CHANGE REQUEST

25.427 CR 99 # rev 2 # Current version: 6.1.0

Title:	# E-DCH Frame format update		
Source:	# RAN3		
Work item code:	# EDCH-lur lub	Date:	# 18/02/2005
Category:	# F	Release:	# Rel-6
	Use <u>one</u> of the following categories: F (correction) A (corresponds to a correction in an earlier release) B (addition of feature), C (functional modification of feature) D (editorial modification) Detailed explanations of the above categories can be found in 3GPP TR 21.900 .		Use <u>one</u> of the following releases: Ph2 (GSM Phase 2) R96 (Release 1996) R97 (Release 1997) R98 (Release 1998) R99 (Release 1999) Rel-4 (Release 4) Rel-5 (Release 5) Rel-6 (Release 6) Rel-7 (Release 7)

Figure 11a: E-DCH UL DATA FRAME structure

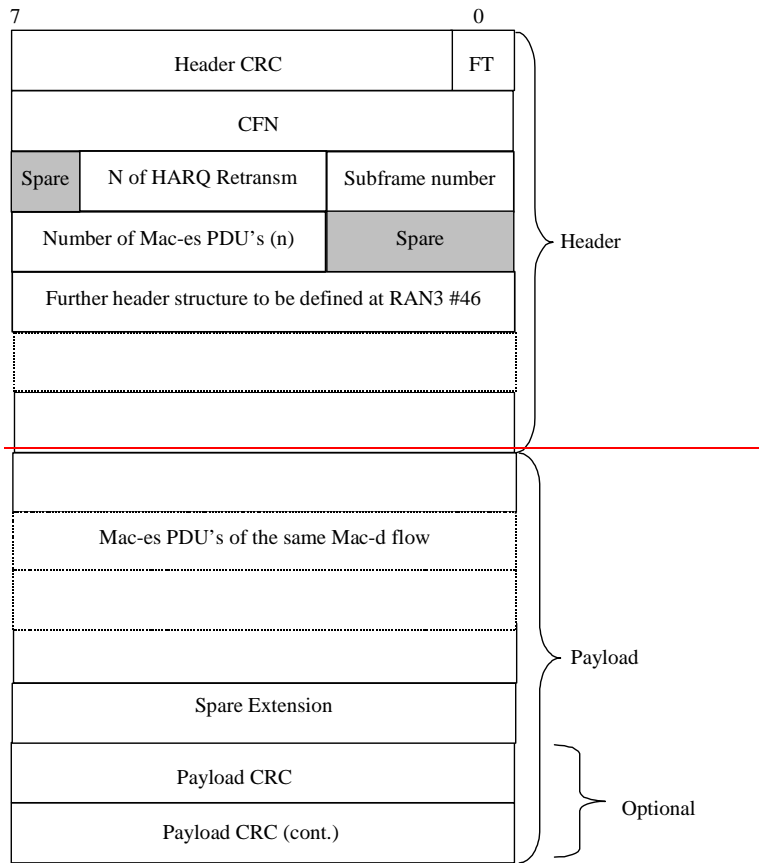
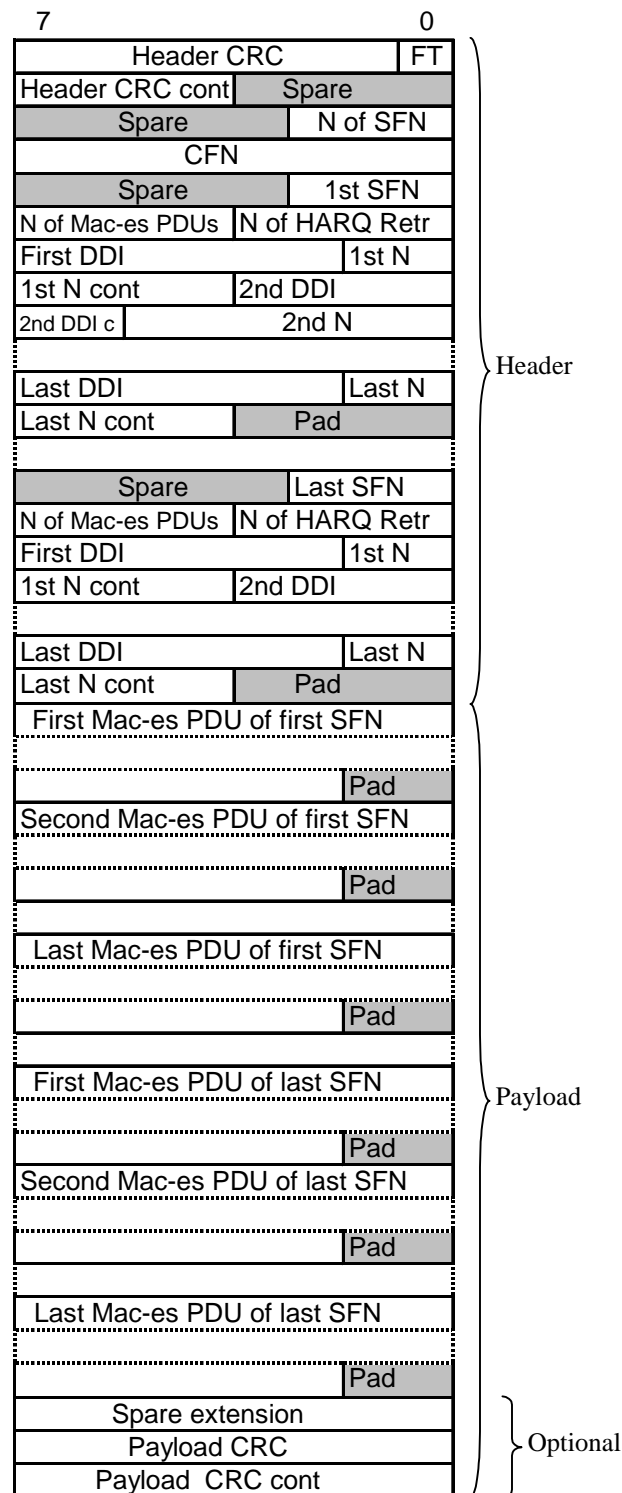
[When there is an odd number of DDI + N field pairs for a subframe, then 4 bits padding is used as shown in the figure in order to have the octet aligned structure.](#)

[If a Mac-es PDU does not fill an integer number of octets, then bit padding is used as shown in the figure in order to have the octet aligned structure.](#)

The *Payload CRC* IE is optional, i.e. the whole 2 bytes field may or may not be present in the frame structure (this is defined at the setup of the transport bearer).
